# Baseline for Autoclass Timing improvement v102

**Insert new item  $T_{Class\_ACS}$  into Table 33–15 as follows:**

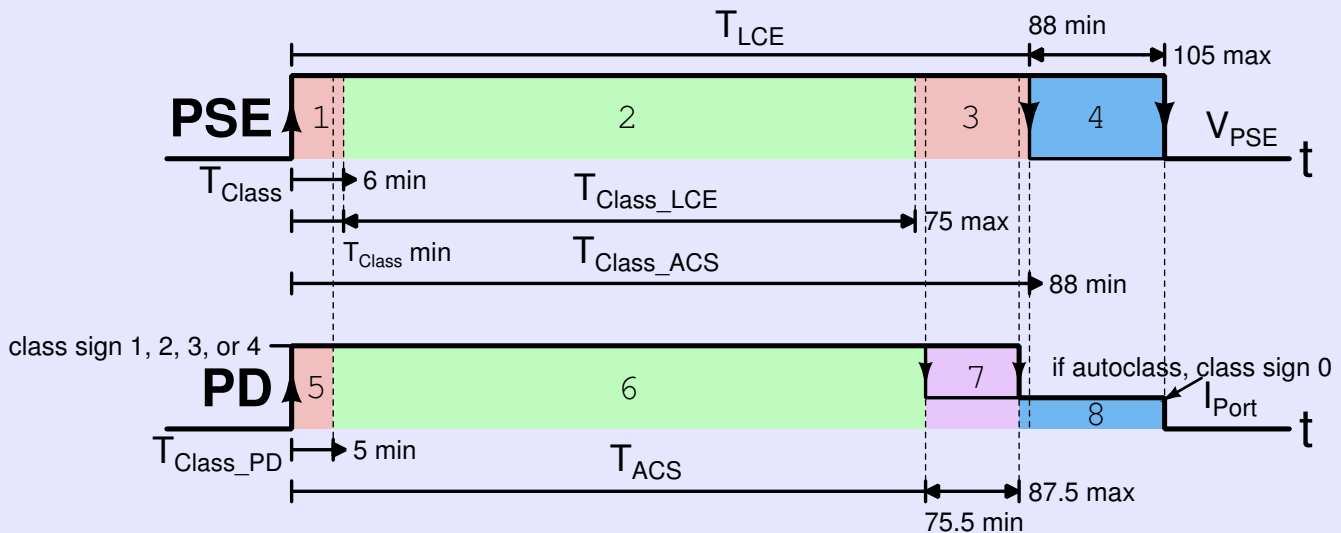
Item	Parameter	Symbol	Unit	Min	Max	Single- or Multiple Event	Additional information
x	Autoclass $I_{Class}$ measurement timing	$T_{Class\_ACS}$	ms	88.0		Multiple	See 33.2.7.3
